**APPENDIX K: ON-SITE WASTEWATER TREATMENT SYSTEM REVISED
CONFORMANCE REVIEW, CITY OF MALIBU ENVIRONMENTAL HEALTH,
ENVIRONMENTAL AND BUILDING AND SAFETY DIVISION (July 16, 2008)**

Subject: 3700 La Paz Lane, Malibu, California 90265; Conformance Review for Office Park Projects, Revisions and Conversion to Coastal Development Permit (CDP 05-106 and CDP 05-107)

**REVIEW OF PROPOSED
WASTEWATER TREATMENT SYSTEM
FOR THE MALIBU LA PAZ DEVELOPMENT**

LOMBARDO ASSOCIATES, INC. 4800 Wilshire Blvd., Suite 1000 Beverly Hills, CA 90210 (310) 276-1111 www.lombardoassociates.com	WASTEWATER SYSTEM FOR LA PAZ RANCH Civic Center-Way City of Malibu COUNTY OF LOS ANGELES STATE OF CALIFORNIA	FIGURE 1-1A
SCALE: 1"=40' DATE: DECEMBER 2007	JULY 2008

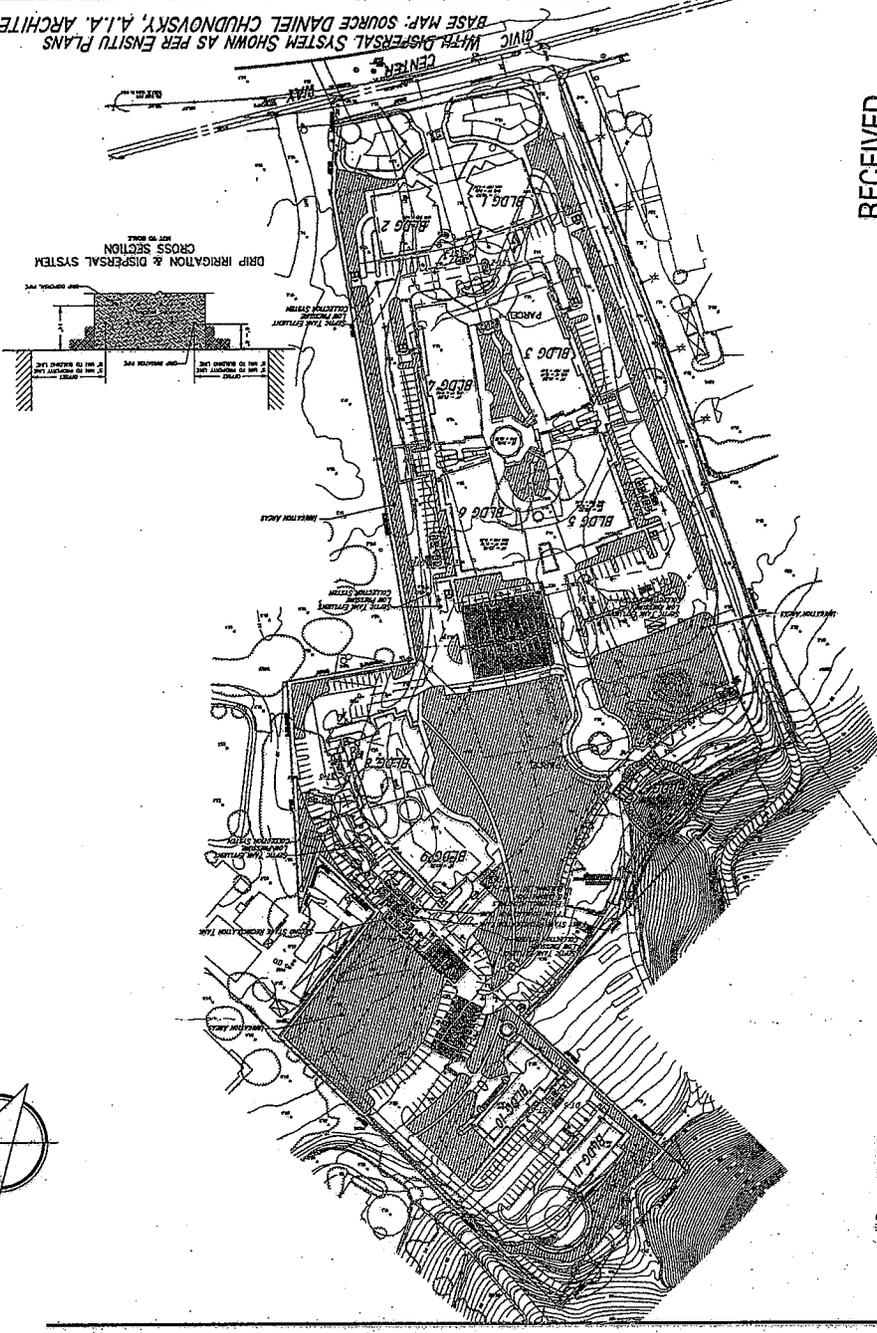
1. This review is for 11 new commercial buildings (CDP 05-106) and for 11 new commercial buildings with a new City Hall building (CDP 05-107). A new alternative onsite wastewater treatment system shall be installed, as shown. The new alternative onsite wastewater treatment system conforms to the City of Malibu Plumbing Code (MPC), and the Local Coastal Plan (LCP).
2. This review relates only to the minimum requirements of the MPC and the LCP, and does not include an evaluation of any geological, or other potential problems, which may require an alternative method of wastewater treatment.
3. This review is valid for one year, or until MPC, and/or LCP, and/or Administrative Policy changes render it noncomplying.

CITY OF MALIBU ENVIRONMENTAL HEALTH	
CONFORMANCE REVIEW	
JUL 16 2008	
SIGNATURE	<i>A. Stuber</i>
THIS IS NOT AN APPROVAL. FINAL APPROVAL IS REQUIRED PRIOR TO THE ISSUANCE OF ANY CONSTRUCTION PERMITS
